SEWAGE DISPOSAL SYSTEM

DEPARTMENT OF HEALTH AND MENTAL HYGIENE

SUBDIVISION _____ LOT _____ ROAD 4310 Linthicum Road

FILE INQUIRY FORM

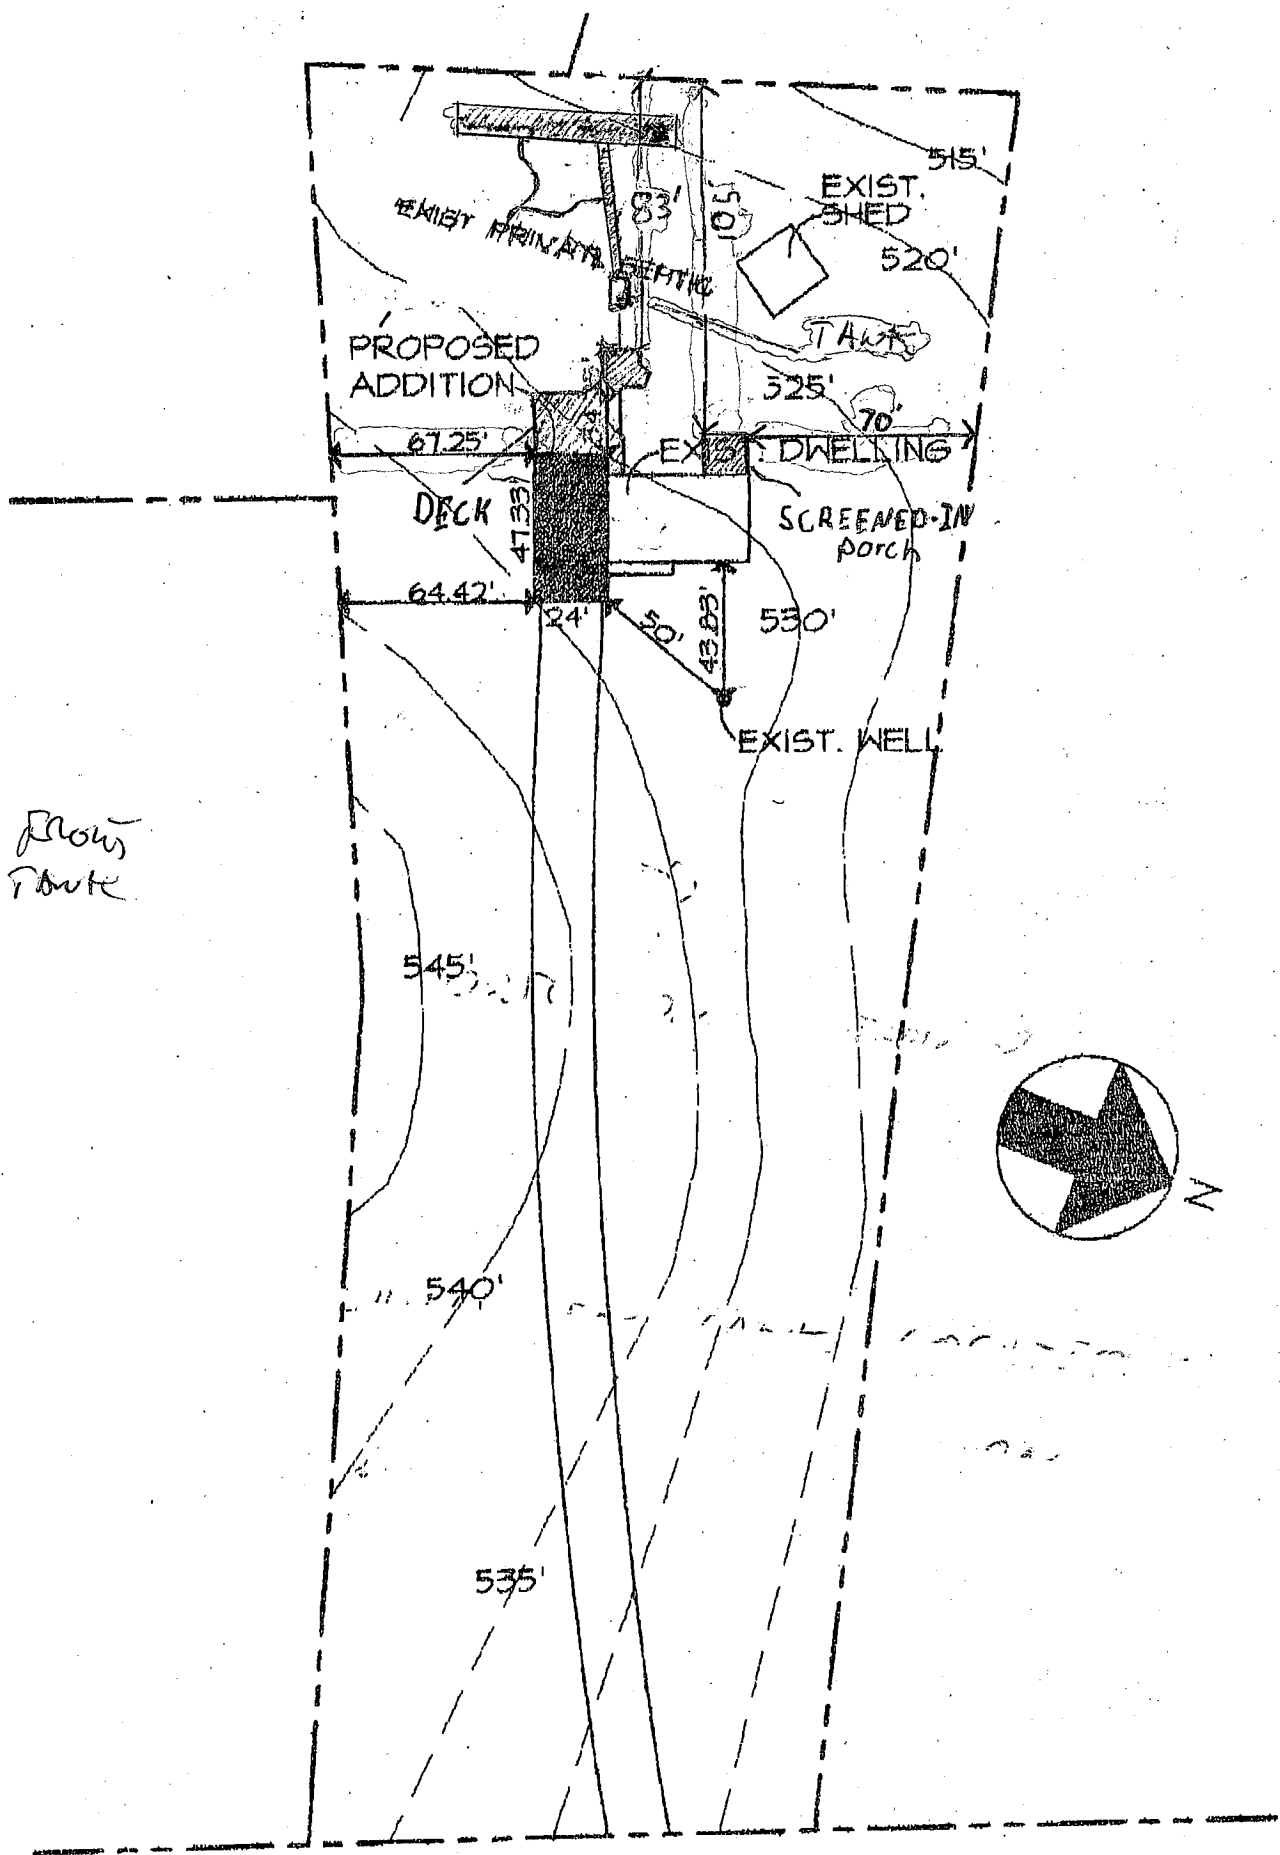
REPAIR - PURPOSE - SEPTIC SYSTEM HAS FAILED.
Call for inspection when ground is opened so sanitarian can recommend repair. 4/12/93

4/13/93
TRENCH OFF OLD DRY WELL

54 FT LONG 10 FT DEEP 7 FT STONE

INLET 3 FT

4310 LINTHICUM ROAD
 HOWARD COUNTY, MARYLAND
 5th ELECTION DISTRICT
 SCALE: 1"=60' DATE: NOVEMBER 5, 2003

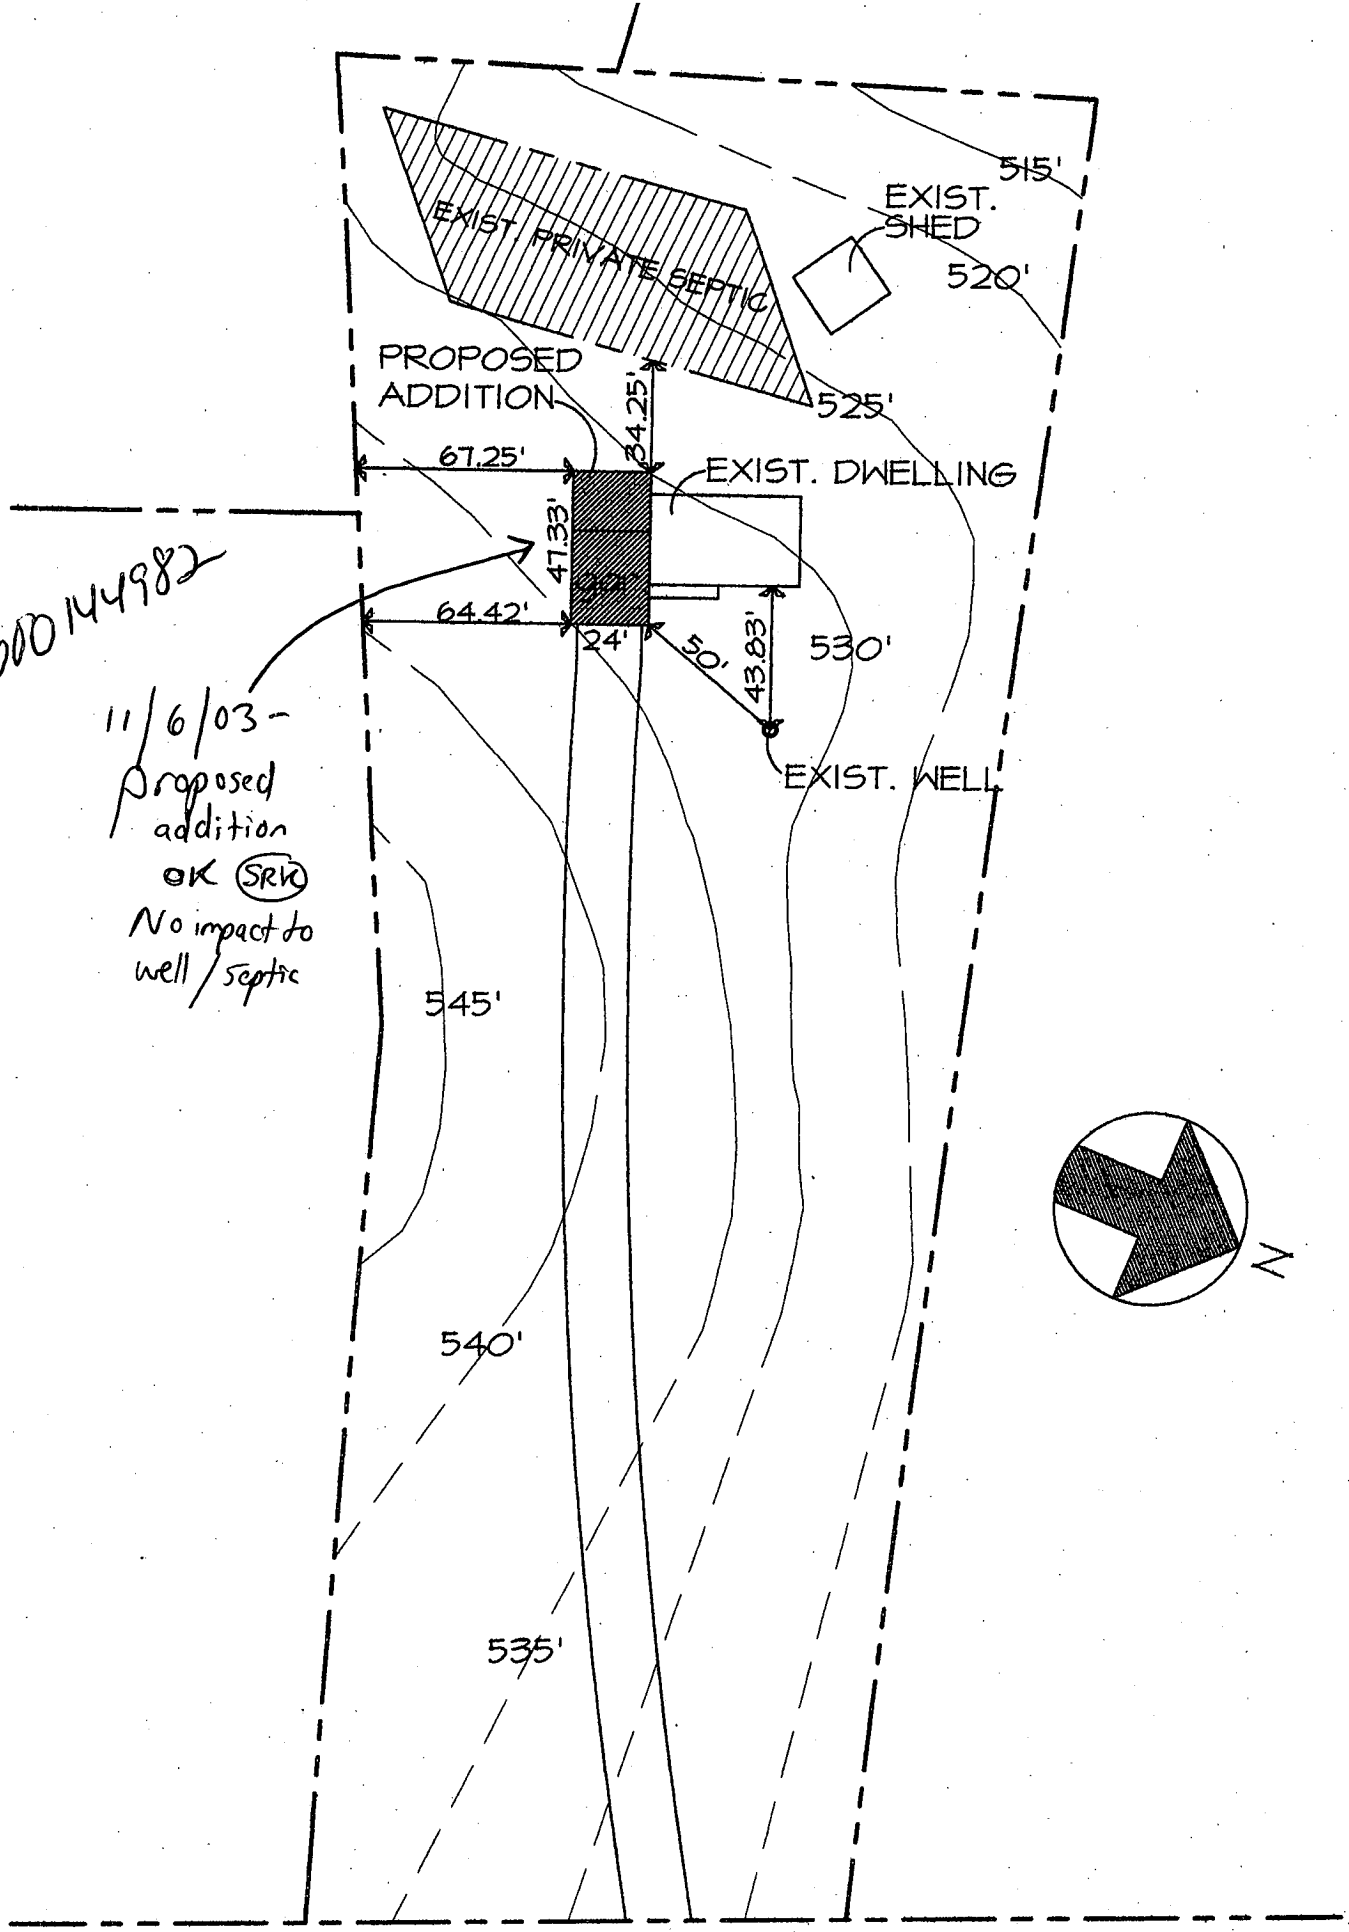
11/6/03 -
Proposed
addition
OK (SRV)
No impact to
well/septic

LOCATION DIAGRAM

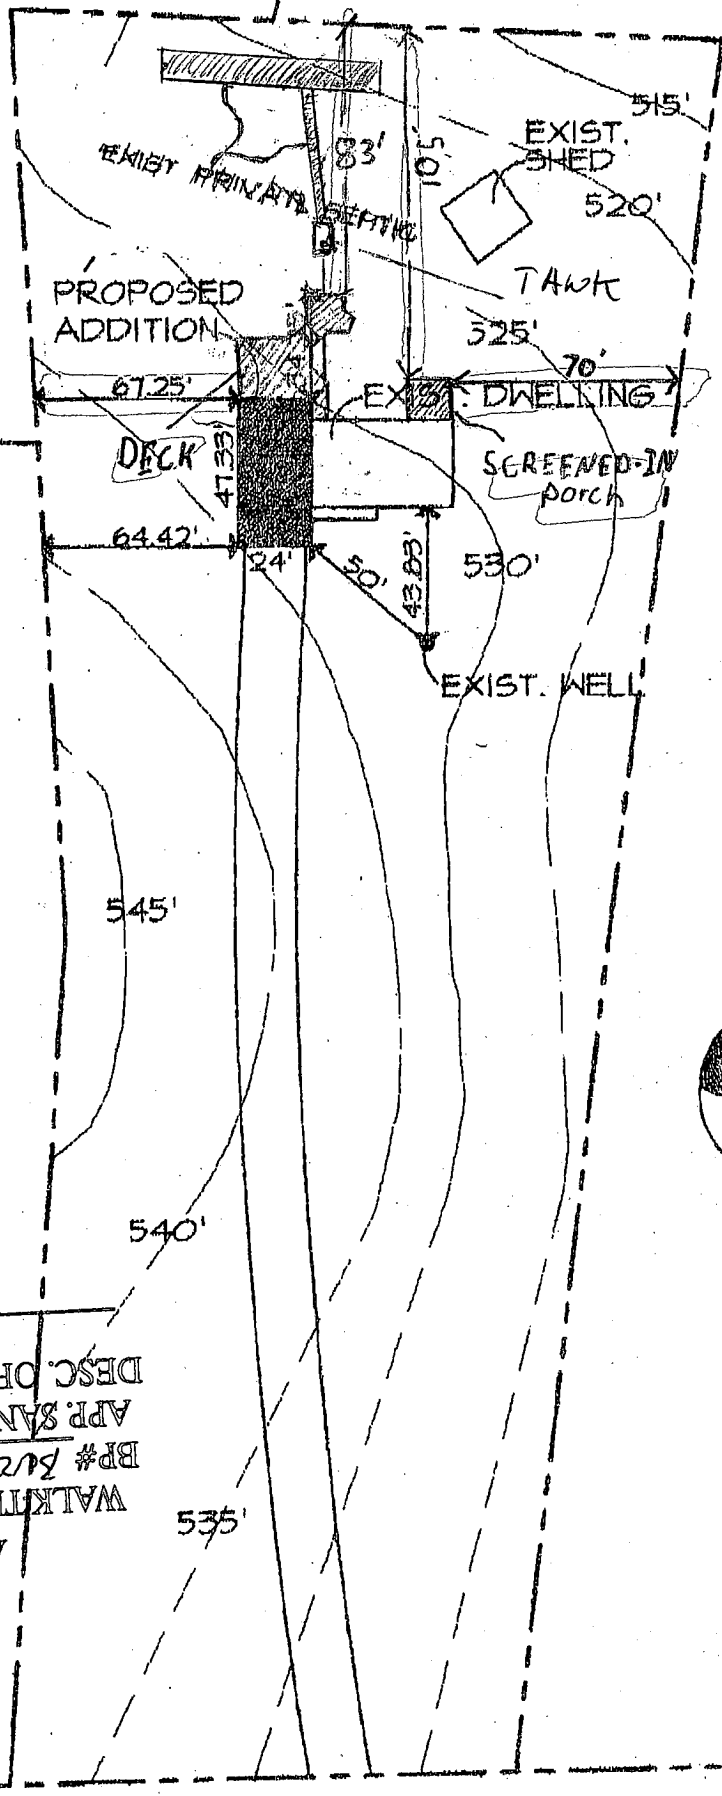
COMMENTS: tank + drywell location do not match as built. Site visit done to verify contractor loc. for building permit for deck.

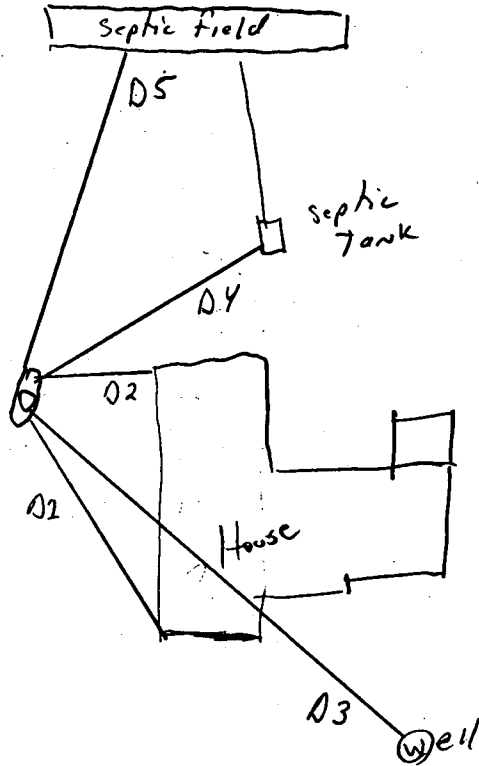
APPROVED

WALKTHRU BUILDING PERMIT
 BP# B01/4877 A#
 APP. SAN Y
 DATE: 9/9/04
 DESC. OF WORK: Screen porch & deck
